Widening of SR 107 From I-75 To SR 11/US129

Value Engineering Study Report

August 2009

Re: Widening of SR 107 from I-75 to SR 11/US 129
Project No. STP-0000-00(311), P.I. No. 0000311
Project No. STP-0000-00(314), P.I. No. 0000314
Project No. STP-0000-00(313), P.I. No. 0000313
Value Engineering Study Report

PROJECT: **WIDENING OF SR 107 FROM CR 264 TO SR 11/US 129**
STP00-0000-00(313), P.I. Number 0000313

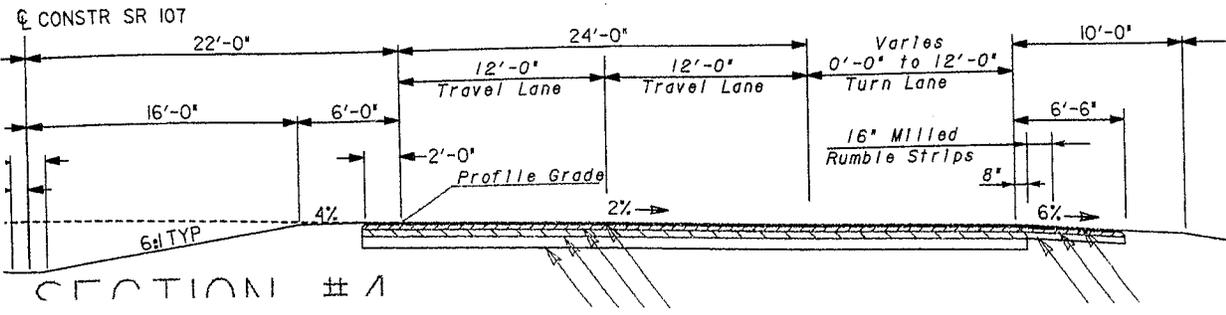
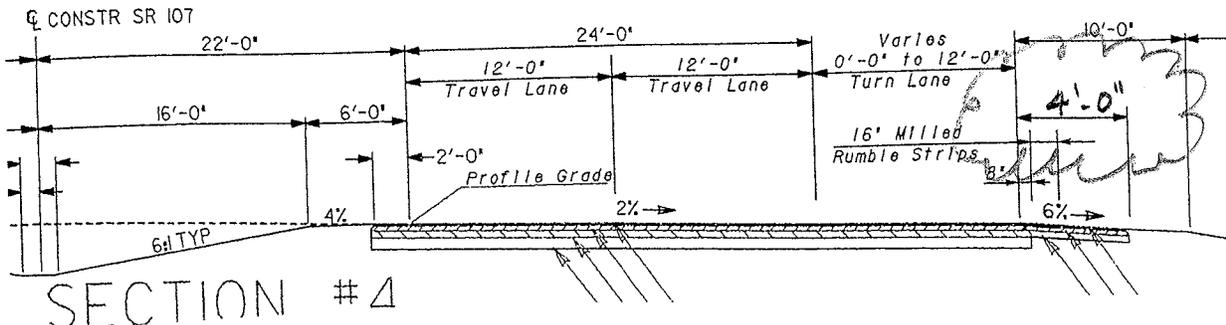
Before consideration was given to bicycles, outside shoulders typically had 4 ft of pavement. Since there is not a bicycle route at this location, there is no reason to provide 6 ft 6 in of pavement.

ALTERNATIVE NO.: T-7

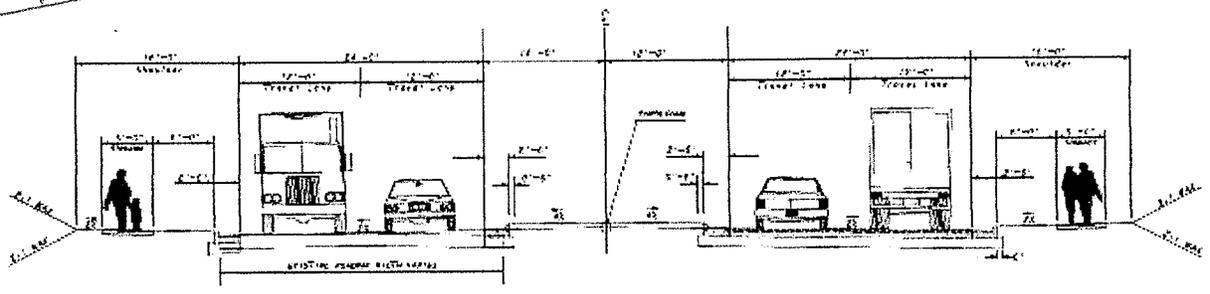
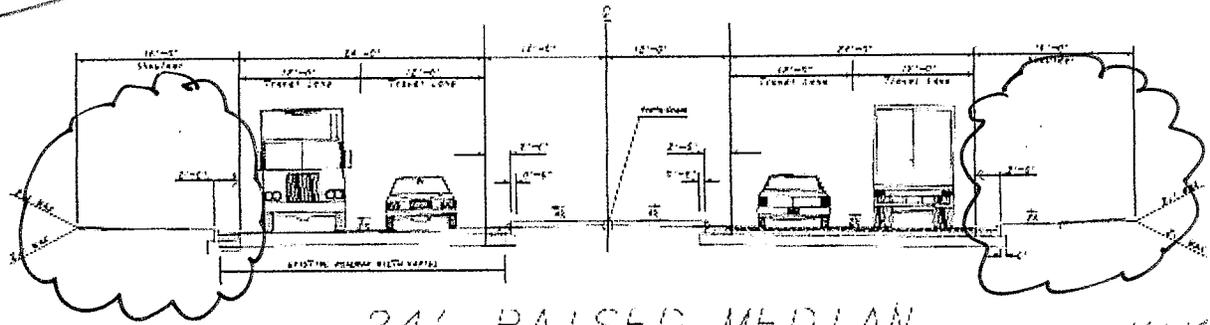
There is not enough demand to justify the proposed sidewalk. With no outstanding numbers of residents in the area, it does not appear that any significant pedestrian demand will occur now through the design year. Grassing the entire shoulder will enable future addition of sidewalks as development occurs.

ALTERNATIVE NO.: **T-9**

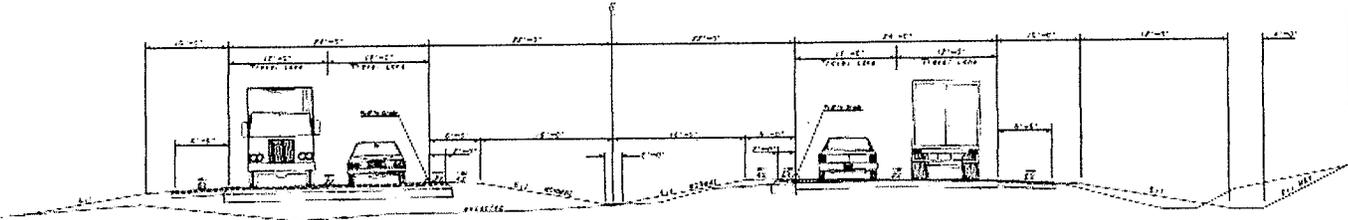
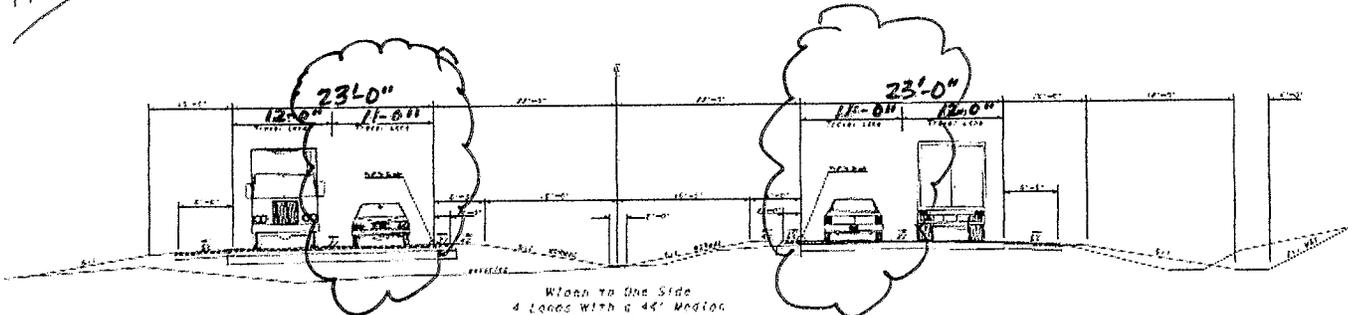
Downtown Atlanta has 11-ft-wide lanes on its freeways without any significant problems. Design year traffic volumes along SR 107 range from 1,875 ADT at CR 264 to 10,950 ADT at SR 11/US 129. Constructing 11-ft-wide inside lanes on SR 107 from CR 264 to SR 11/US 129 will save material and construction requirements without sacrificing the quality of traffic movement. Keeping 12-ft-wide outside lanes will provide enhanced goods movement for 30 percent truck traffic traveling through the corridor.

ALTERNATIVE NO.: *T-10*

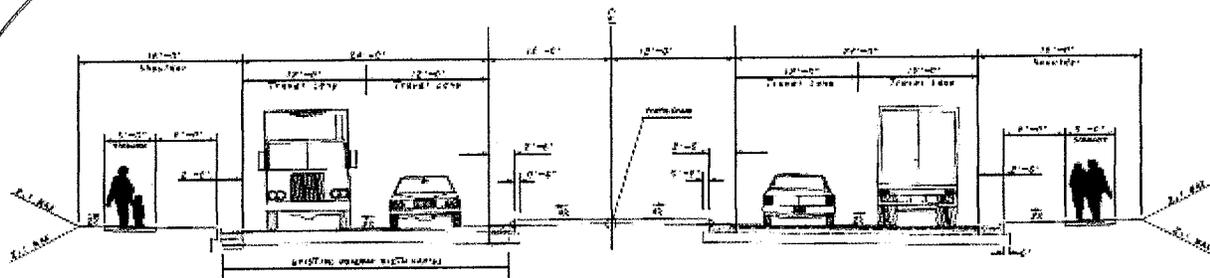
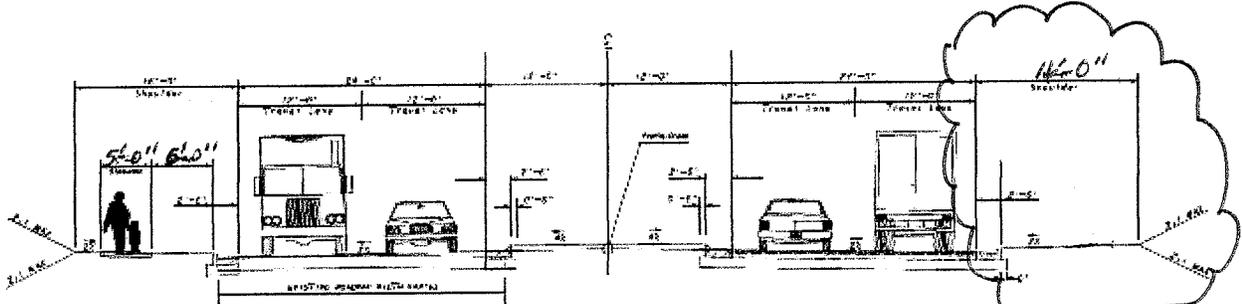
Remove the 5-ft-wide sidewalk from the south side of SR 107 from Sta. 490+69 to Sta. 620+46.8.

2/4
 Alt. G-1
 (313)

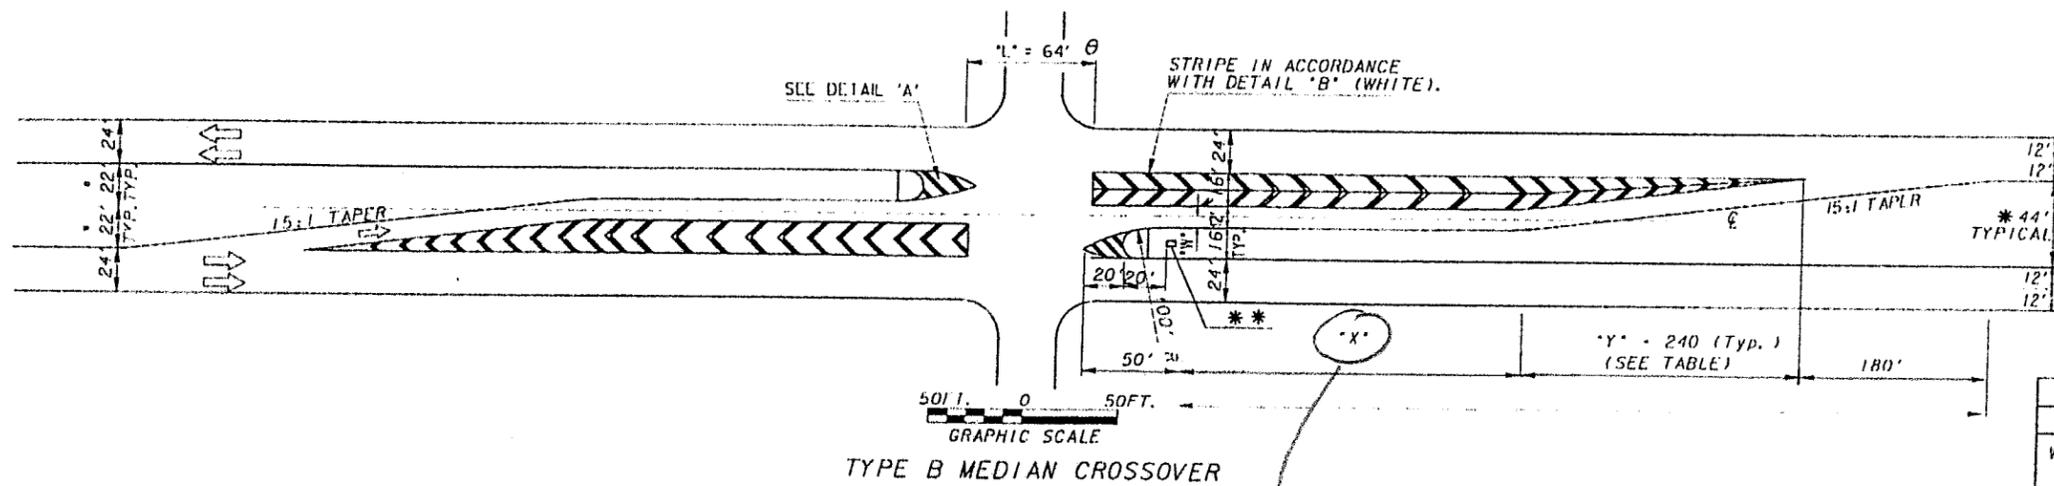
The original design uses the maximum “x” length of 450 ft for storage and deceleration for left-turn lanes per GA. Construction Detail M-3.

Use the minimum “x” length of 300 ft for storage and deceleration for left-turn lanes per GA. Construction Detail M-3.

ALTERNATIVE NO.:
G-17

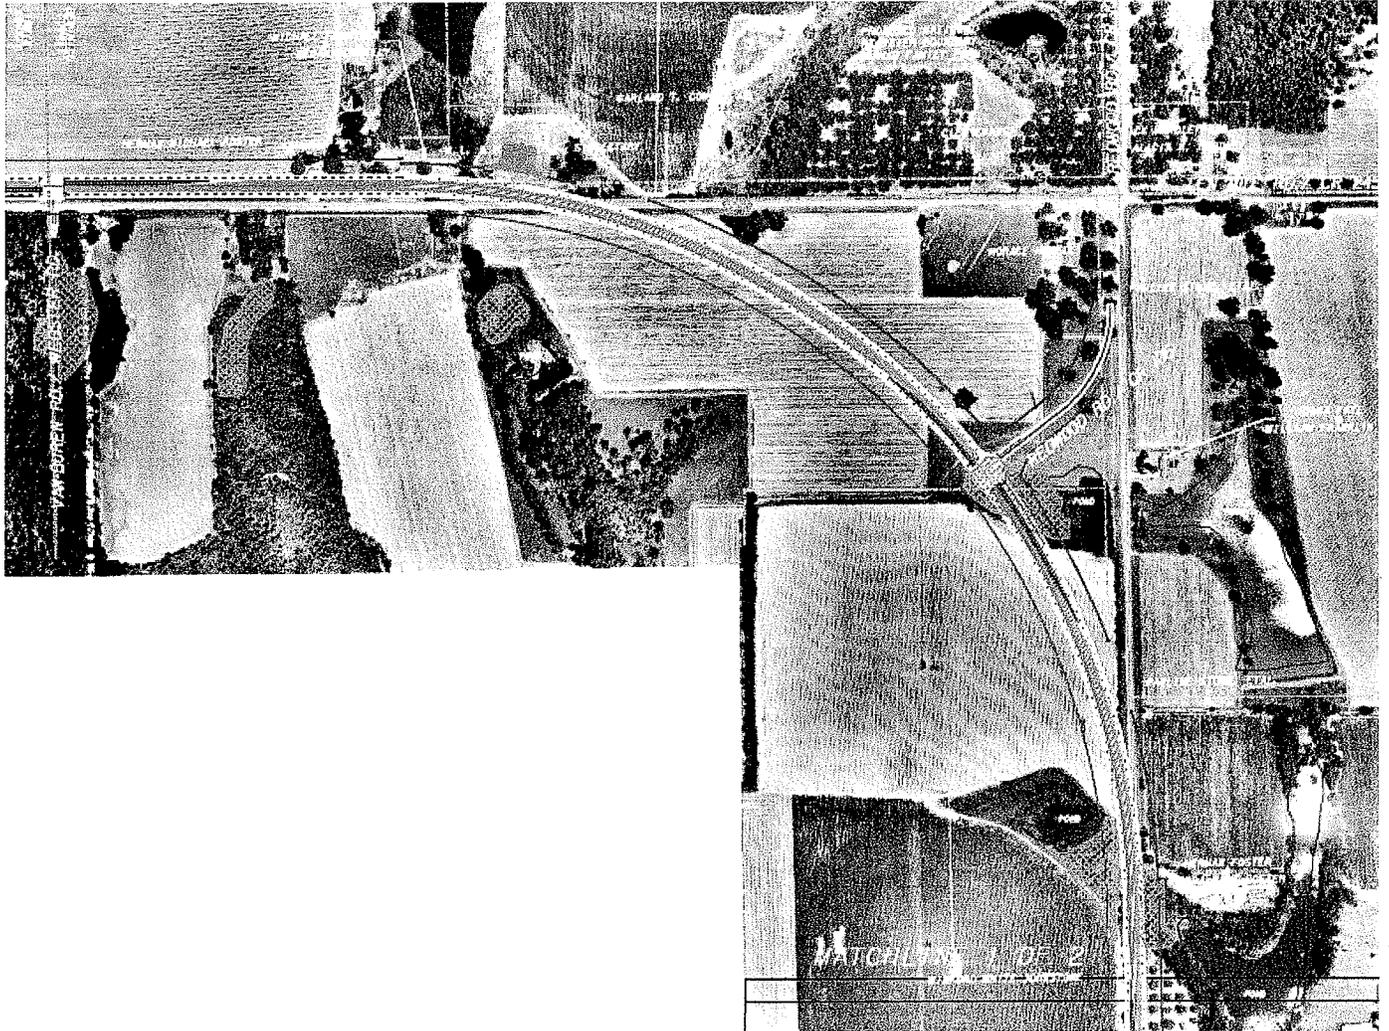
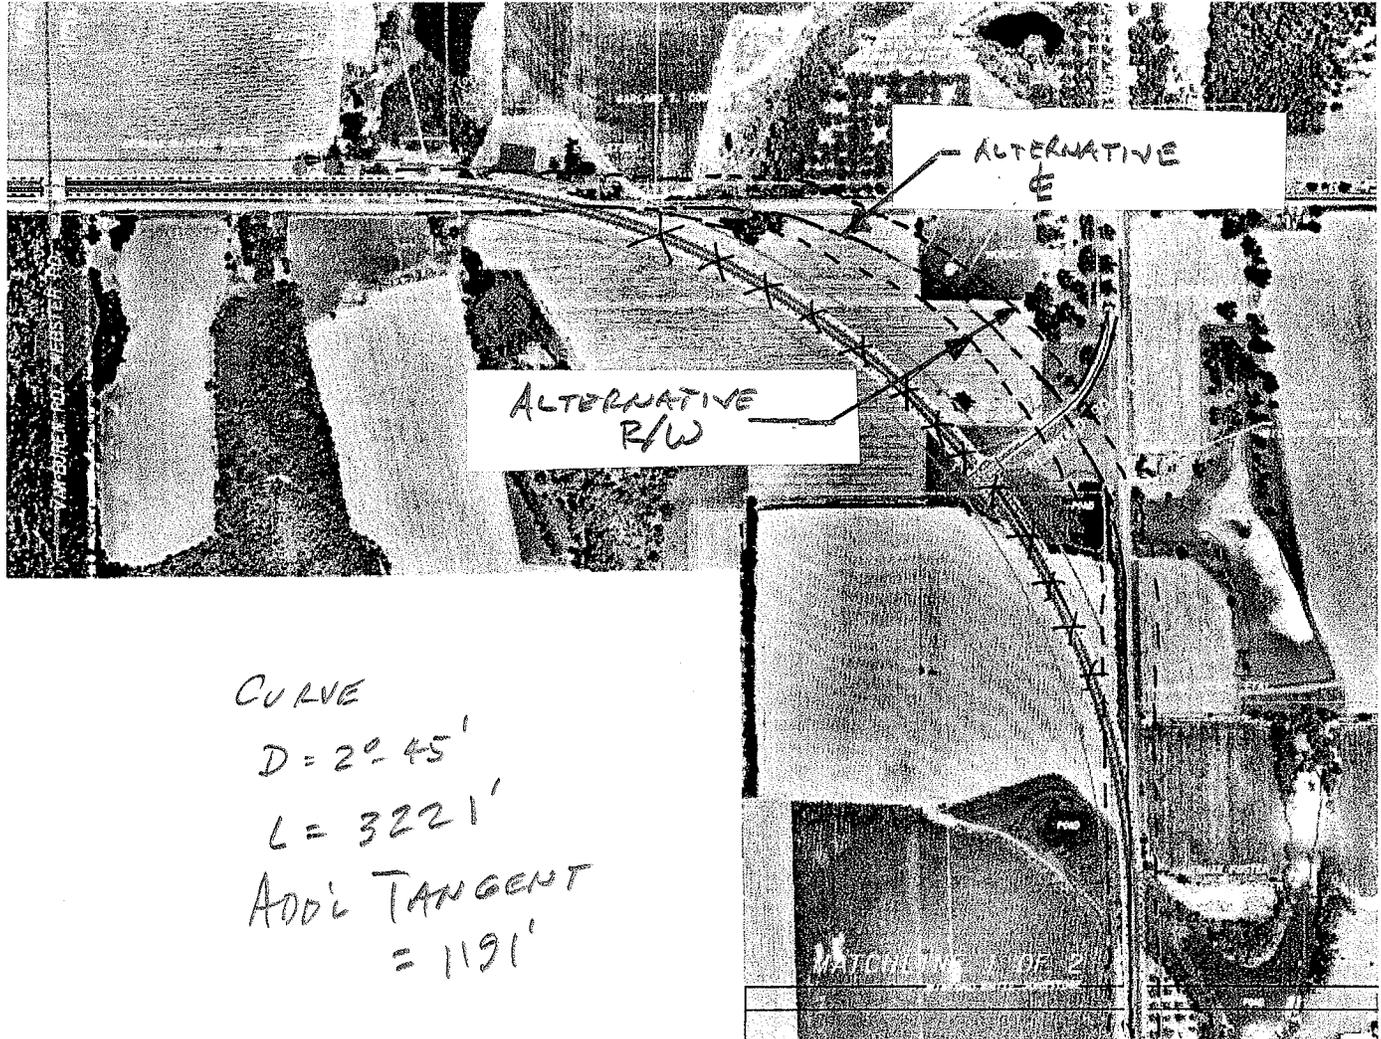
The flat curve provided in the original design requires a large amount of right-of-way and construction on new location. It is designed for 65 mph. The speed limit drops to 55 mph at SR 125, which is 2 1/8 miles east of Van Buren/Webster Road (on the original alignment). Dropping the speed limit to 55 mph at Van Buren/Webster Road would create only a minor inconvenience to the traveling public. This alternative would also allow a shorter Redwood Road Connector.

Provide a 2°-45 ft minute curve with a length of 3,221.43 ft and extend the tangent section by 1,191 ft on each end.

CURVE
 $D = 20-45'$
 $L = 3221'$
ADD'L TANGENT
 $= 1191'$

PROVIDE A ONE-MILE PASSING LANE
IN EACH DIRECTION BETWEEN HAWKINS RD.
AND ELEANOR CIRCLE

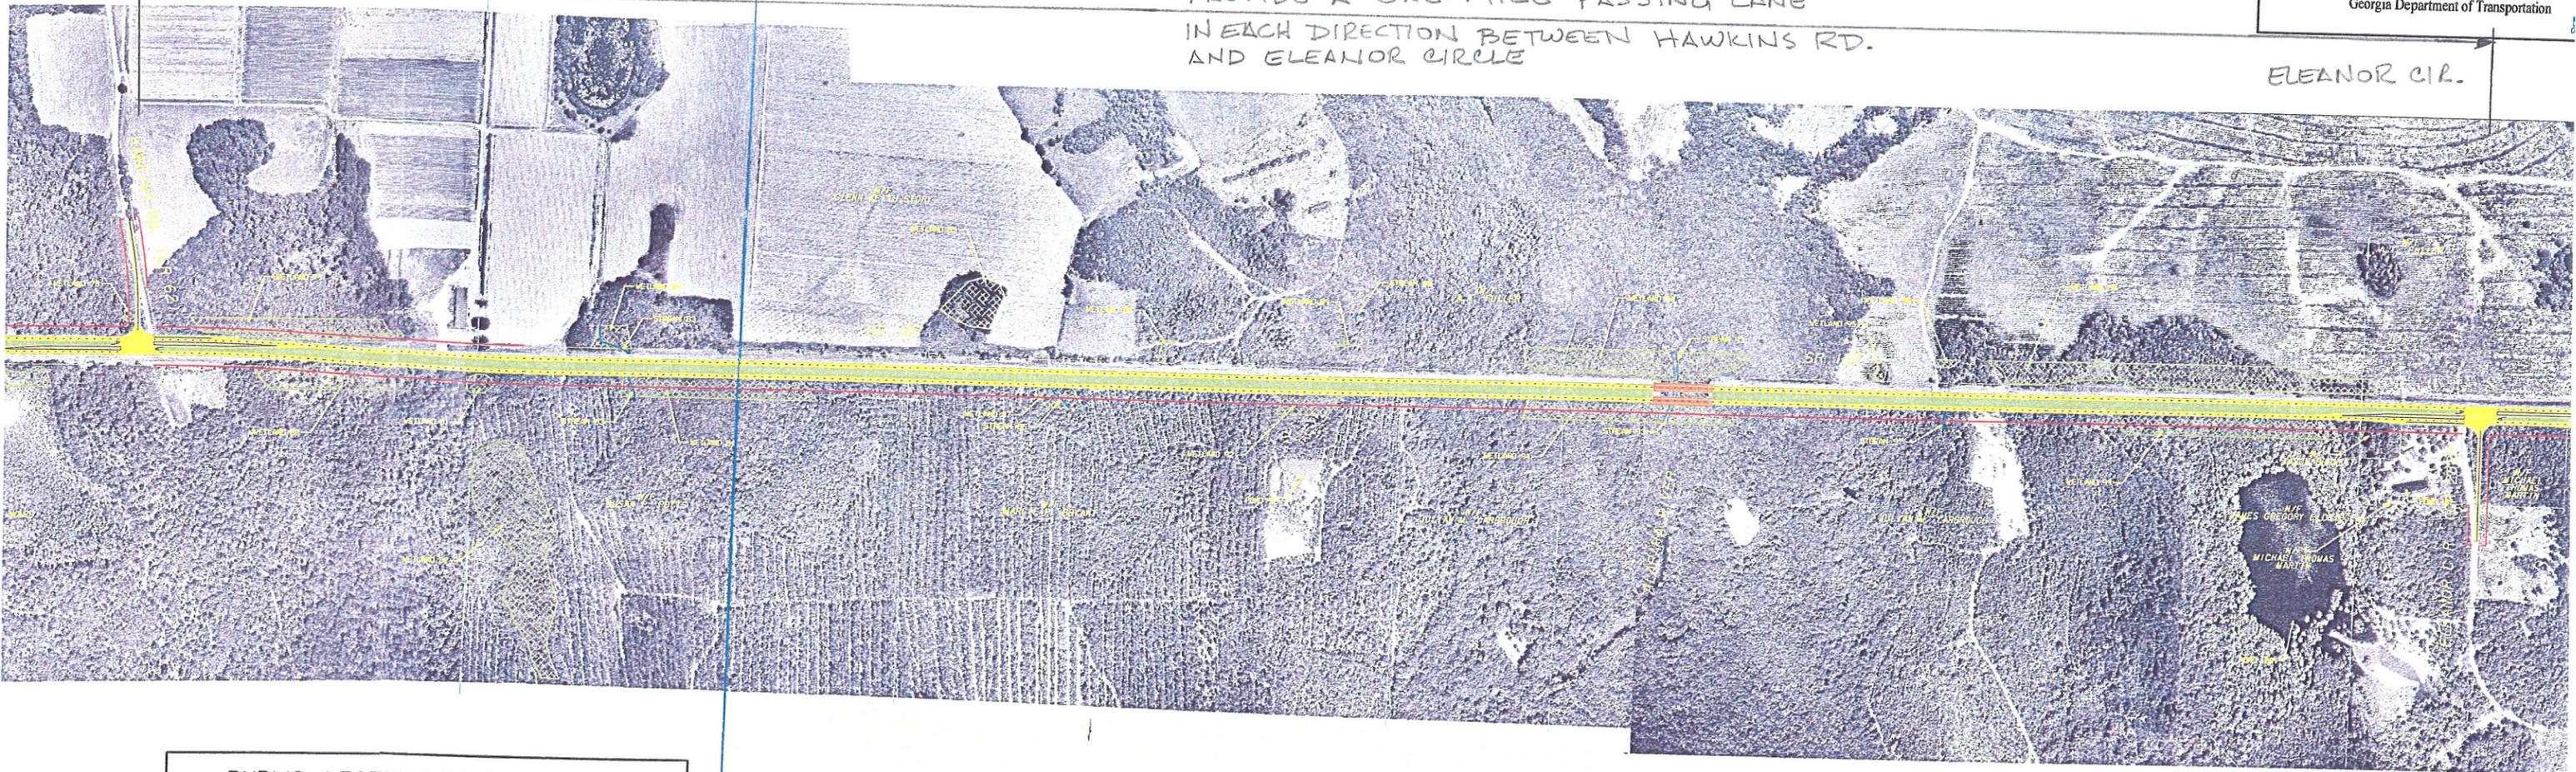
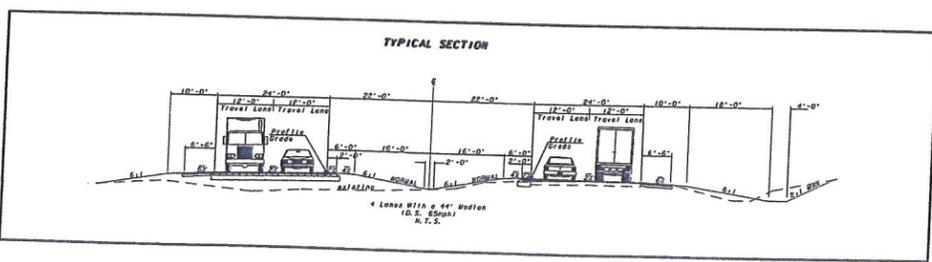
Retain the existing two-lane highway and provide one, one-mile passing lane in each direction between Hawkins Road/CR 62 and Eleanor Circle/CR 282. Includes improvements to all intersections (see sheet 2 of 3) and reconstruction of 14% of the existing two-lane rural section to correct sight distance deficiencies.

T-6

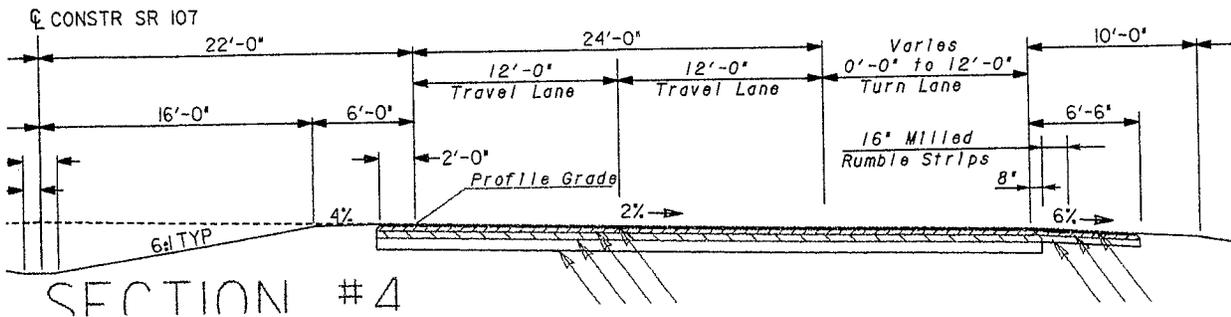
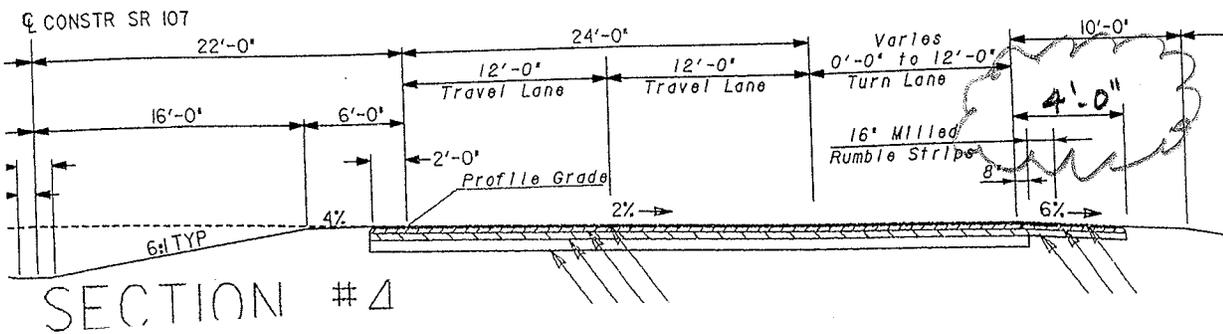
Before consideration was given to bicycles, outside shoulders typically had 4 ft of pavement. Since there is not a bicycle route at this location, there is no reason to provide 6 ft 6 in of pavement.

ALTERNATIVE NO.: *T-9*

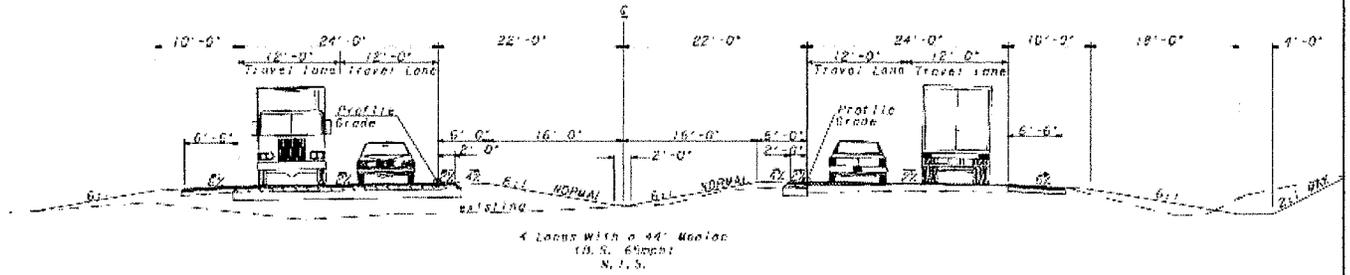
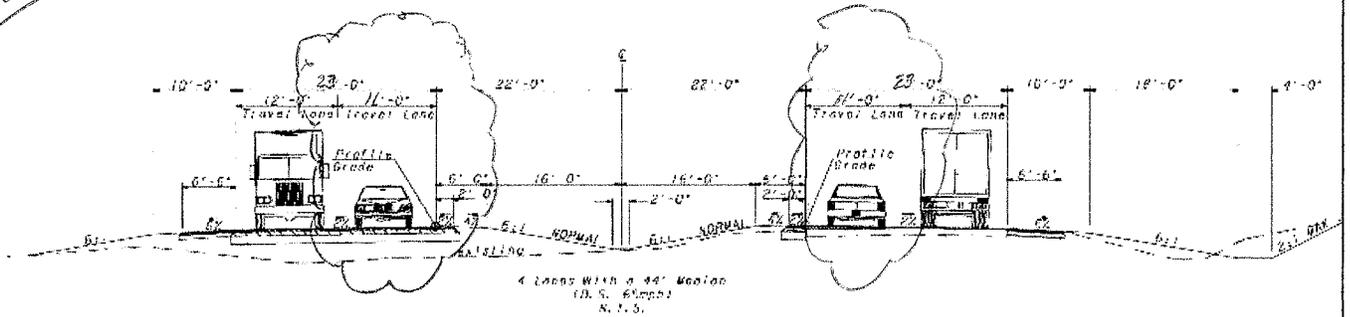
Downtown Atlanta has 11-ft-wide lanes on its freeways without any significant problems. Design year traffic volumes along SR 107 from I-75 to CR 250 range from 1,600 ADT at CR 250 to 1,700 ADT at CR 264. Constructing 11-ft-wide inside lanes on SR 107 from CR 250 to CR 264 will save material and construction cost without sacrificing the quality of traffic movement. Keeping 12-ft-wide outside lanes will provide enhanced goods movement for 30 percent truck traffic traveling through the corridor.
